**RECORD DRAWING  
DECEMBER 27, 2013**

PROJECT NAME: RUTLAND SOUTHERN VERMONT REGIONAL AIRPORT  
CLARENDON, VERMONT  
PROJECT NUMBER: AV14-8008-300  
FILE NAME: 207h124reloc.fnc\util-RD.dgn LOT DATE: 12/30/2013  
PROJECT LEADER: F. WALSH DRAWN BY: M. KEMP  
DESIGNED BY: G. D'AMICO CHECKED BY:  
FENCE & UTILITY POLE RELOCATION PLAN SHEET 16 OF 29

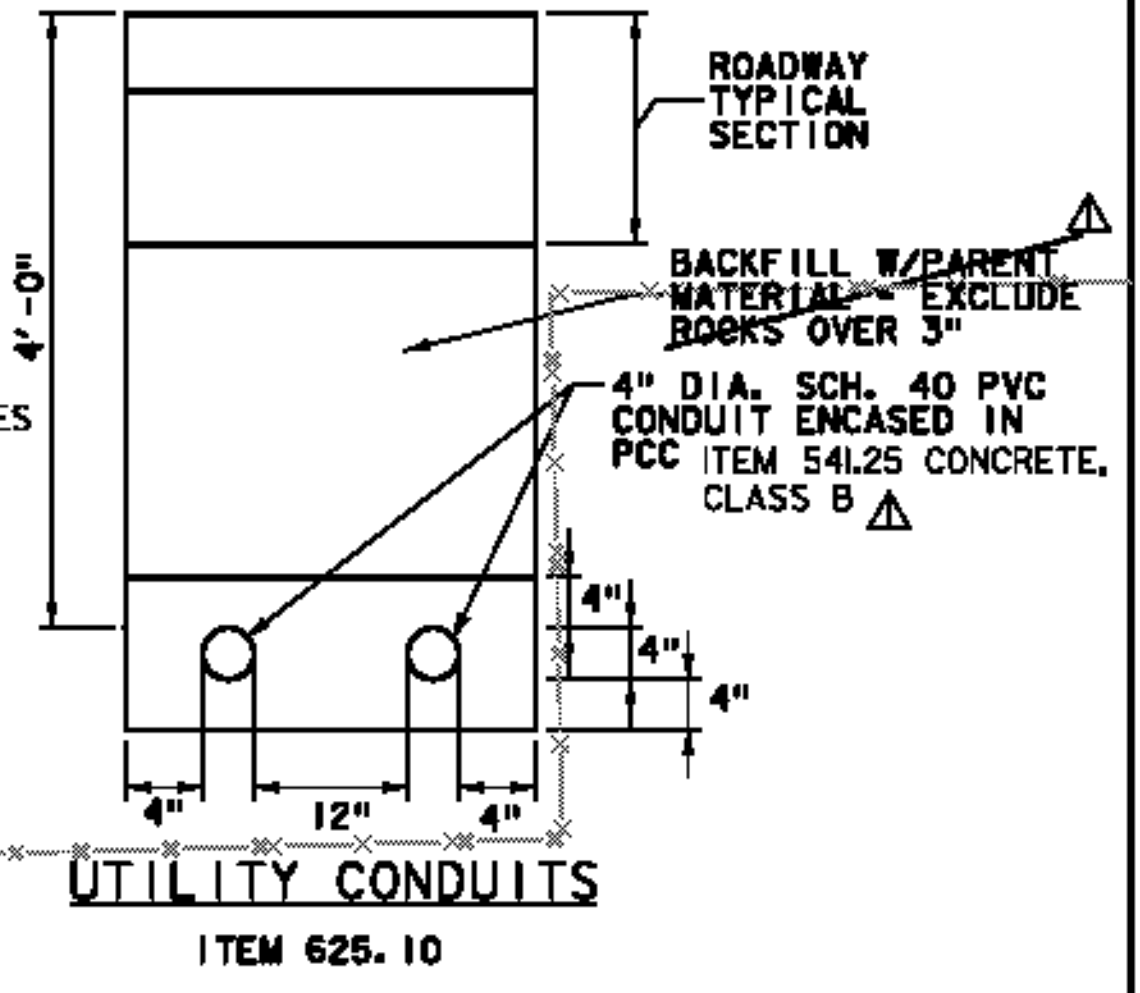
CONSTRUCT NEW 8' CHAIN LINK FENCE  
ITEM 620.13  
390' RT STA 152+00 TO 300' LT  
STA 160+00 APPROX.  $\Delta$

REMOVE EXISTING CHAIN LINK FENCE  
ITEM 620.55  
390' RT STA 152+00 TO 300' LT  
STA 160+00 APPROX.  $\Delta$

END FENCE INSTALLATION  
TIE TO EXISTING  
 $\Delta$  TIE-IN ADJACENT  
TO EXISTING GATE

1. NEW 8' CHAINLINK FENCE TO BE VINYL CLAD (GREEN).
2. UTILITY RELOCATION BY OTHERS.
3. REMOVAL OF EXISTING AIRPORT CHAIN LINK FENCE WILL REQUIRE AIRSIDE ACCESS. CONTRACTOR TO COORDINATE ACCESS WITH AIRPORT MANAGEMENT AND ENGINEER @ LEAST 48 HOURS IN ADVANCE.
4. BOTTOM OF FENCING FABRIC IS TO BE PARALLEL TO GROUND. MAXIMUM SPACE BETWEEN FABRIC AND GROUND TO BE 1" FILL SPACE WITH STONE FILL, TYPE I ITEM 613.10 AS DIRECTED BY THE ENGINEER. TYPE I STONE FILL PLACED ALONG BOTTOM OF FENCE THROUGHOUT ENTIRE LENGTH.  $\Delta$
